## TECHNICAL MEMORANDUM

Approval no: DEV2019/1074  
Date: 26 March 2020

To: Richard Bender - EDQ  
From: Ralph Williams / Shaun Leinster  
DesignFlow  
Date: 24 February 2020  
Subject: Carseldine Urban Village - Addendum to Carseldine Urban Village – Local flood assessment to support Stage 1 development

**ACOUSTIC FENCE  
LAYOUT PLAN  
SHEET 1 OF 2**

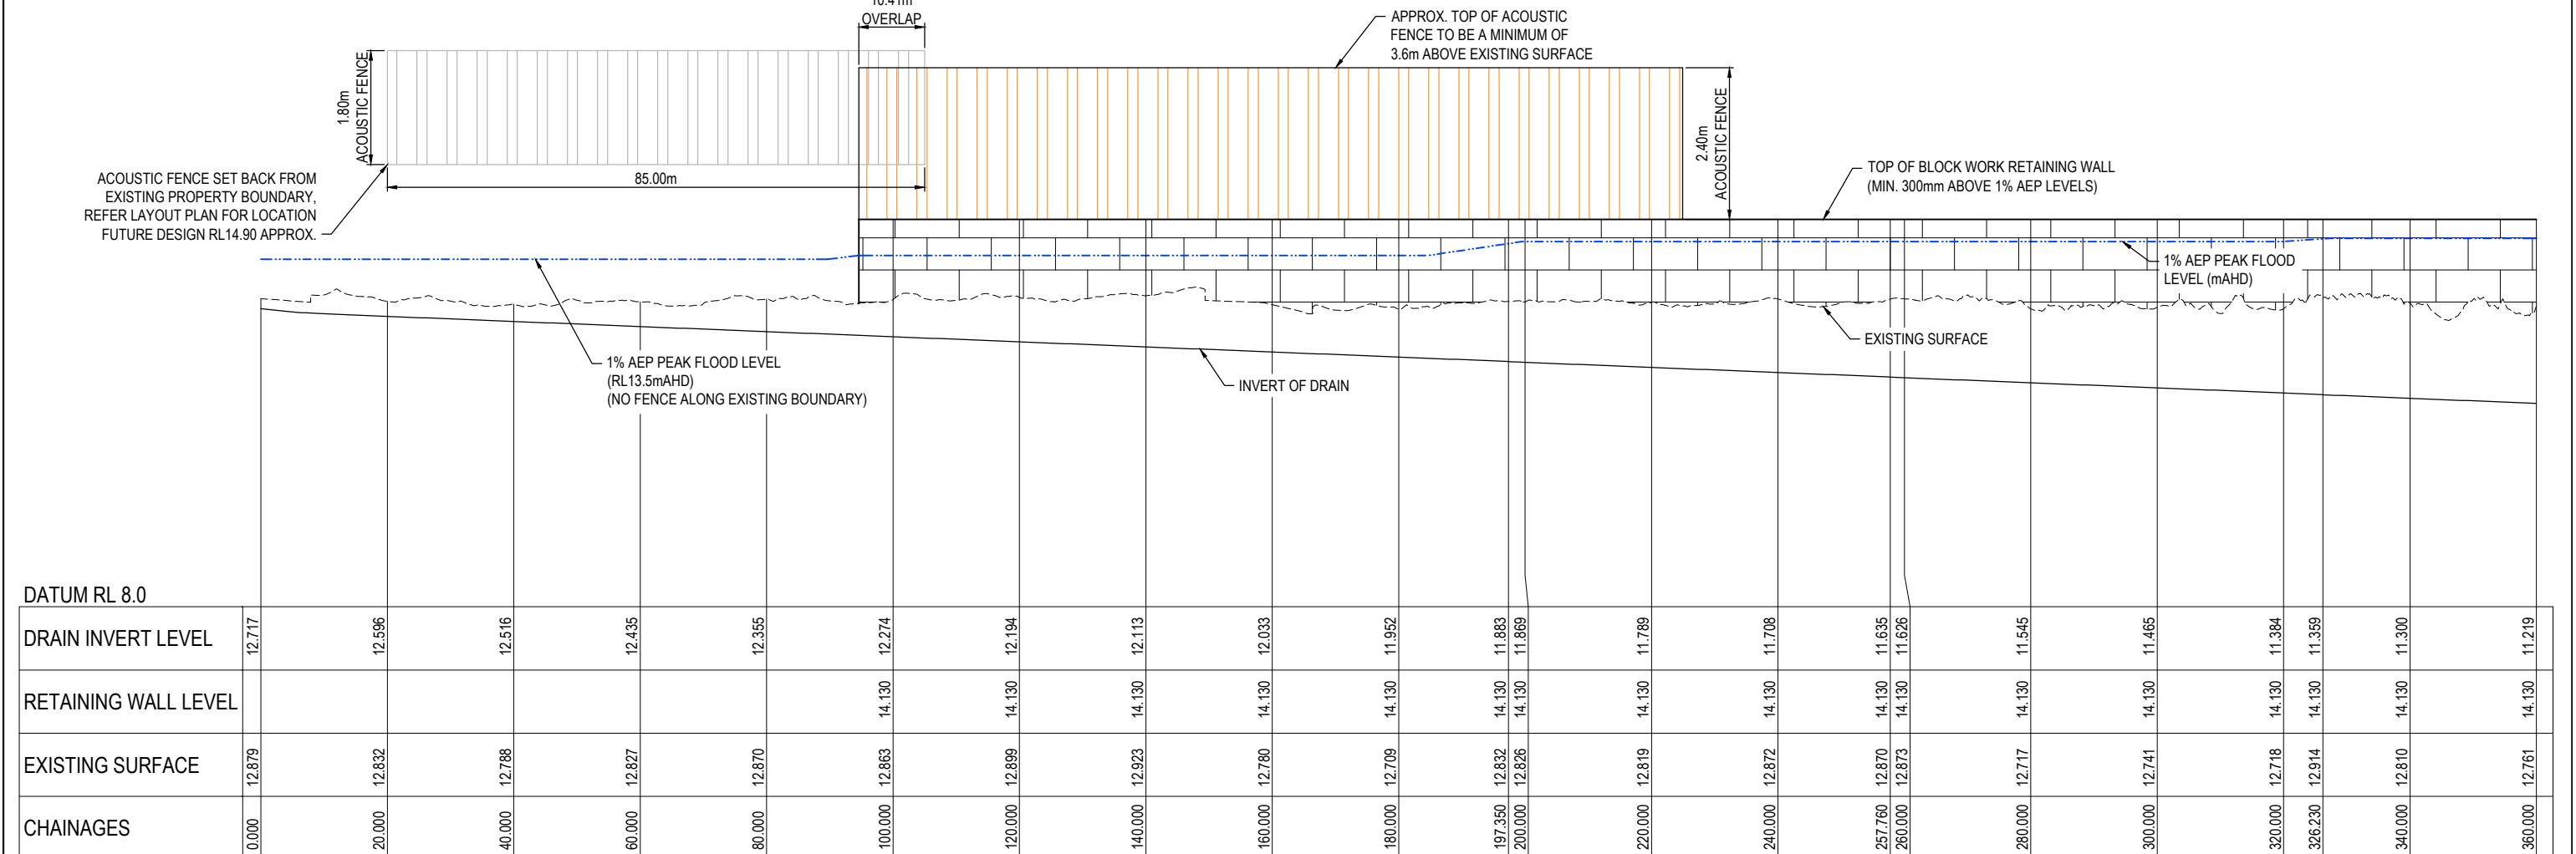
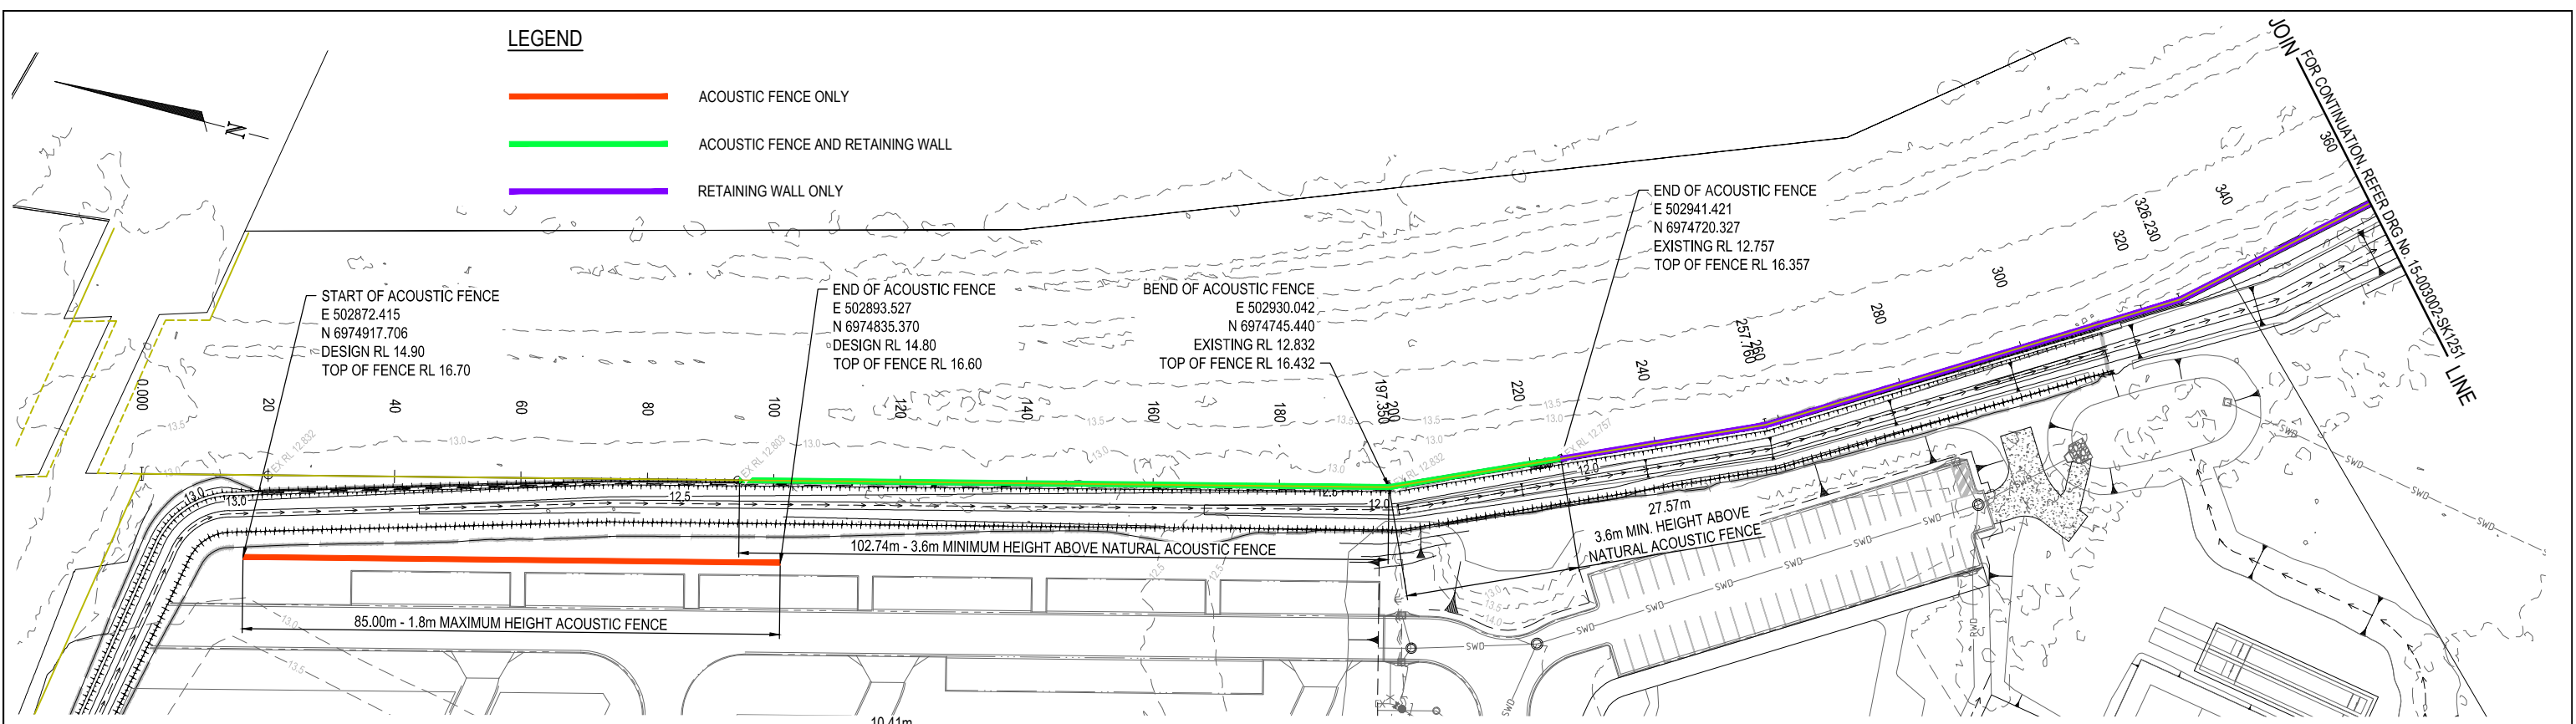
Since the Stage 1 3<sup>rd</sup> party review, EDQ have had discussions with TMR regarding flood impacts along the rail corridor zone. TMR have stated that they will not accept any impact in this zone. Although local modelling for Stage 1 had indicated no impacts along the rail corridor with no flood barrier included, there remains a risk in the regional flood case that impacts could occur in this corridor with no flood barrier in place. Whilst this does not cause flooding of the rail line, EDQ have advised that the flood bund is to be constructed as part of Stage 1 works to eliminate the risk of flooding along the rail corridor zone.

**Attachment 1** provides details of the proposed flood barrier works. This flood barrier will be combined with the acoustic fence, where applicable. This is consistent with what was previously proposed to eliminate impacts along the rail corridor zone, as detailed in the Carseldine Urban Village - Updated Stormwater Management Plan (DesignFlow October 2019). The top flood barrier levels are based on predicted 100 year flood levels associated with ultimate development conditions, with a minimum 300mm freeboard applied. These flood barrier levels are insensitive to the flap valve on the 1200mm RCP and are related to regional flood effects.

**RECOMMENDED ACTION RELEVANT TO STAGE 1: INSTALL THE FLOOD BARRIER ALONG EASTERN BOUNDARY OF THE SITE AS PART OF STAGE 1 WORKS AS PER ATTACHMENT 1**
